Clarification 1

ނަންބަރު No:	TES/2022/W-045		
ފޮތްކުރާ ގޮތު Project:	Construction of 30 Bed Hospital in Sh.Milandhoo		
އުފުލާ ދުވަހު Issued Date	14 th June 2022		
ސަފުހާގެ އަދަދު No. of Pages: -09	ބޮޑުވަނަ Boq: -00	ވަނަވަނަ Drawings: -00

Construction of 30 Bed Hospital in Sh.Milandhoo

CLARIFICATION 1

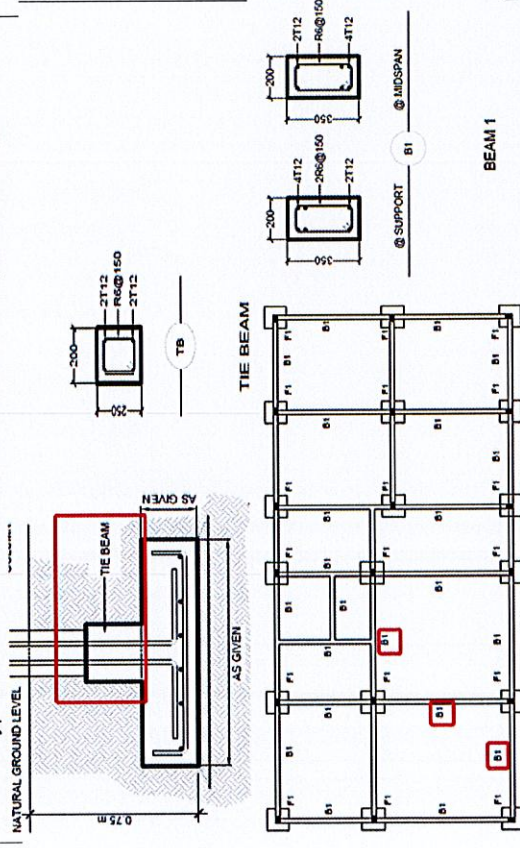
As per Drawing no. S1.04(14), there is a tie beam within the Footing F1. Further, as per drawing no. S1.01(11) - "footing and tie beam plan" indicates another type of beam marked as "B1". Please confirm whether both the types i.e. "Tie beam" and "B1" are form a part of design.

"B1" is correct type of beam to be used.
